UNITED STATES
NUCLEAR REGULATORY COMMISSION

FACILITY: Cooper Nuclear Station

SUBJECT: SUMMARY OF MEETING WITH NEBRASKA PUBLIC POWER DISTRICT
REGARDING COOPER NUCLEAR STATION DESIGN-BASIS ACCIDENT
RADIOLOGICAL CONSEQUENCES ASSESSMENT METHODOLOGY AND
MAIN STEAMLINE ISOLATION VALVE (MSIV) LEAKAGE PATHWAY SEISMIC
QUALIFICATIONS

Cooper Nuclear Station's Plan For Seismic Qualification of MSIV Leakage Pathway to the Condenser

METHODOLOGY

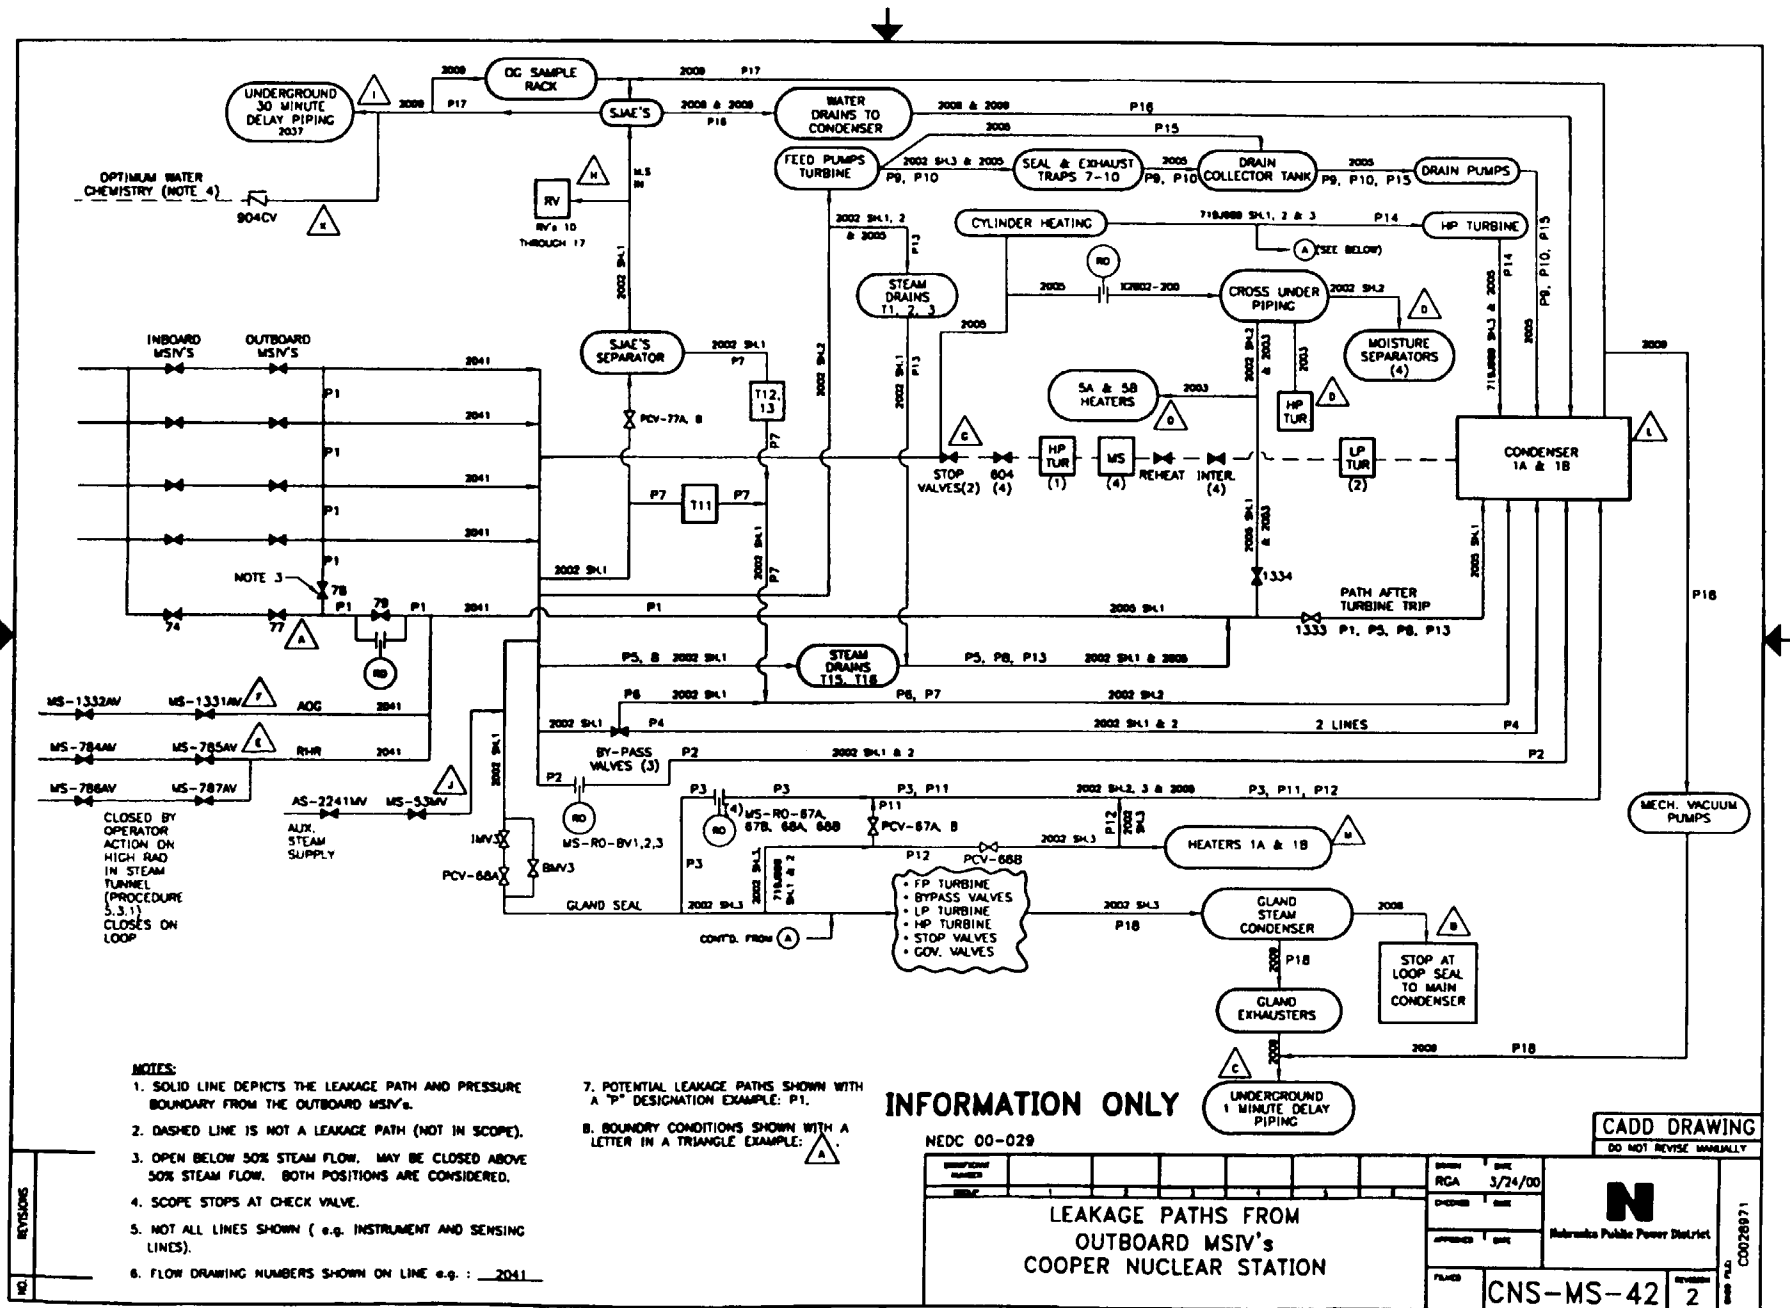
*justify using
at Cooper*

*justified for
the anchorage*
